1. In this Final Rule, to meet our responsibility under sections 205 and 206 of the Federal Power Act (FPA)¹ to remedy undue discrimination, the Commission adopts standard procedures and technical requirements for the interconnection of large wind plants. The Commission requires all public utilities that own, control, or operate facilities for transmitting electric energy in interstate commerce to append to the Large Generator Interconnection Procedures (LGIPs) and Large Generator Interconnection Agreements (LGIAs) in their Open Access Transmission Tariffs (OATTs) the Final Rule Appendix G adopted here. These standard technical requirements provide just and reasonable terms for the interconnection of wind plants.² The rule recognizes the technical differences of wind generating technology, and benefits customers by removing unnecessary obstacles to further development of wind generating resources while ensuring that reliability is protected.

Appendix G—Interconnection Requirements for a Wind Generating Plant

Figure 1 Proposed low voltage ride-through standard

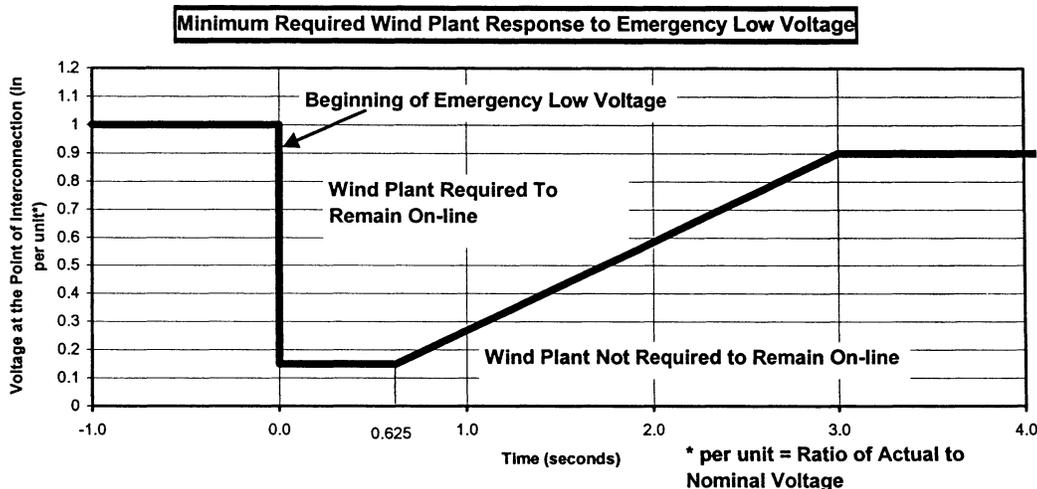
18. Several commenters, including AWEA,¹⁹ Western, FirstEnergy, and the Midwest ISO, state that they support the low voltage ride-through standard in Figure 1 of the NOPR. Midwest Reliability Organization suggests, however, that the standard could be in article 9.6 of the LGIA. CenterPoint contends that the reliability concerns presented by the failure of a large wind plant to ride through a low voltage event also exist if other generators also fail to ride through such events, and thus would apply a low voltage ride-through requirement to all generators. Western supports the standard as proposed, with the understanding that it may need to be modified later if it causes unforeseen problems on the transmission system.

20. Additionally, several entities dispute the specific time periods and associated voltage levels set forth in Figure 1 of the proposed Appendix G. American Superconductor states generally that the proposed low voltage ride-through curve in Figure 1 of the NOPR is unrealistic and does not resemble voltage situations that wind plants are likely to encounter. It also argues that the low voltage requirement proposed in the NOPR is not comparable to what is required of conventional generators. Midwest ISO TOs, CenterPoint and Xcel assert that requiring the low voltage ride-through capability to go only to 15 percent of the rated line voltage (as set out in Figure 1 of the NOPR) may be too high and may present reliability problems. They recommend that the Figure 1 low voltage ride-through profile require the wind turbine to ride through low voltage at zero percent of the rated line voltage for 150 milliseconds. NUSCo recommends that the Commission require wind generators to ride through a fault with zero percent of the rated line voltage at the point of interconnection for 250 milliseconds (15 cycles). American Transmission argues that the low voltage ride-through curve of Figure 1 should show the voltage to be at 0.90 per unit prior to time zero. ISO New England states that to the extent the Commission adopts a low voltage ride-through requirement, it should require wind plants to remain connected to the transmission system for a zero voltage level for the time period associated the typical time it takes to clear a normal design contingency fault.²⁰

21. Several of the commenters, including AWEA, Gamesa, and GE suggest that the low voltage ride-through standard should be clarified to apply only to three-phase faults. AWEA also asks that the requirement be clarified to state that a wind plant would not be expected to continue to operate in low voltage situations where the wind farm is tripped off-line following a fault if (a) this action is performed intentionally under a special protection scheme, or (b) if the fault is on the Transmission Provider's side of the Point of Interconnection and clearing the fault would effectively

disconnect the wind plant from the system. Midwest ISO TOs and Montana-Dakota Utilities also seek clarification regarding application of the proposed standard to unbalanced phase voltages.

²⁵ Additionally, a number of commenters suggest low voltage ride-through levels and timing or cycling standards different from those reflected in the NOPR Appendix G, Figure 1.

32. We also clarify certain portions of the low voltage ride-through standard. First, we clarify that the low voltage ride-through requirement, and the time periods and associated voltage levels set forth in Appendix G, Figure 1, apply to three-phase faults.²³ This is because three-phase faults are the most severe, whereas two-phase or single-phase faults drop the voltage to a level not as low as that specified in Figure 1. Further, in response to AWEA, we clarify that a wind plant is not required to satisfy the standard in Appendix G, Figure 1 if the wind plant is intentionally tripped off line following a fault under a "special protection scheme"²⁴ agreed to by the Transmission Provider. These situations may include a fault on the Transmission Provider's side of the Point of Interconnection, as well as a fault other than a three-phase fault covered by the low voltage ride-through standard.

35. With respect to Midwest ISO TOs' concern that Appendix G, Figure 1 does not contain information on how the standard would apply to unbalanced voltages in close proximity to the point of interconnection,²⁵ we note that it is impossible to identify all possible conditions and circumstances that may arise on the transmission system. The low voltage ride-through standard is a general one that will be adequate under most circumstances. We recognize that special circumstances may occur. These may be identified by the System Impact Study, which should identify any additional protection requirements in addition to this standard. We also note that, as discussed below, the Commission permits variations from the Final Rule Appendix G that are "consistent with or superior to" the standard provisions, that are based on regional reliability council requirements, or that are offered by independent entities such as Regional Transmission Organizations (RTOs) or Independent System Operators (ISOs).

36. Similarly, we are not persuaded to alter the specific time periods and associated voltage levels in Figure 1 of the NOPR Appendix G. The low voltage ride-through standard proposed in that figure and adopted here is close to the standard used in other countries and was presented to the Commission by representatives of the wind industry as an achievable requirement. Several commenters, including Transmission Providers, support the standard as one that would safeguard reliability. The Western Electricity Coordinating Council (WECC), a regional reliability council, has approved a similar low voltage ride-through standard. The standard we adopt in this Final Rule is an international standard that has been accepted for use by the Alberta Electric System Operator and Germany, and was developed following detailed study. We do not believe it would be appropriate to deviate from such a widely-accepted

A wind generating plant shall be able to remain online during voltage disturbances up to the time periods and associated voltage levels set forth in the standard in Figure 1, below, if the Transmission Provider's System Impact Study shows that low voltage ride-through capability is required to ensure safety or reliability.
